Environmental Impact Assessment

Herndon Farms

A Chatham County Active Adult Community

Environmental Impact Assessment Addendum Response to Peer Review For Herndon Farms

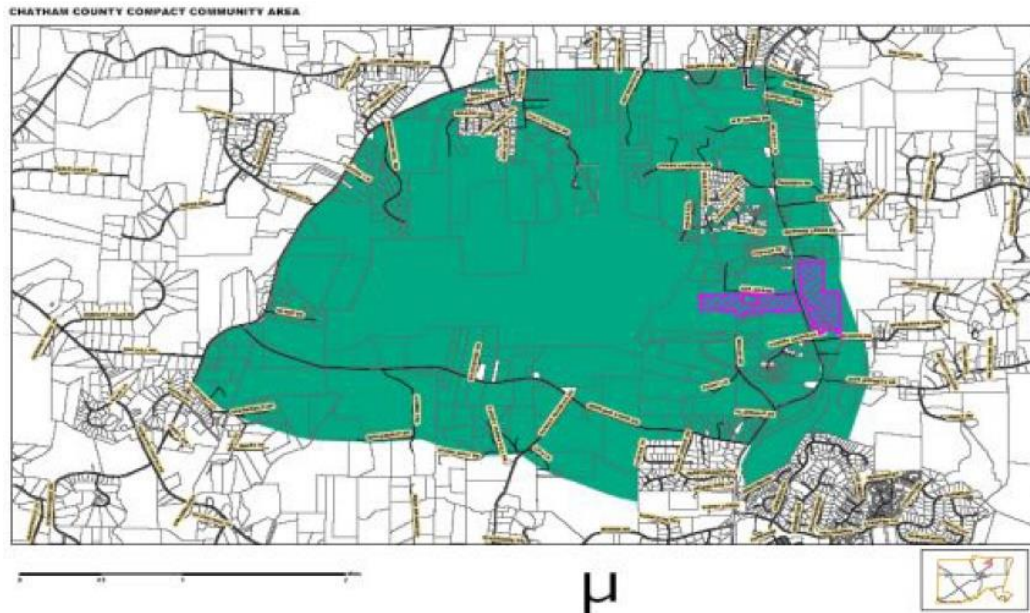
14. Show and describe any proposed stormwater control devices. Reviewer's

Comments: SCMs are shown, but no details are given about sizing, type of SCM proposed, pipe connections, discharge, or maintenance.

- a. The preliminary storm control plans are attached as Exhibits **B.6.1**, **B.6.2** and **B.6.3**. Detailed SCM information will not be decided until a detailed survey and engineering are performed before Final Plat.
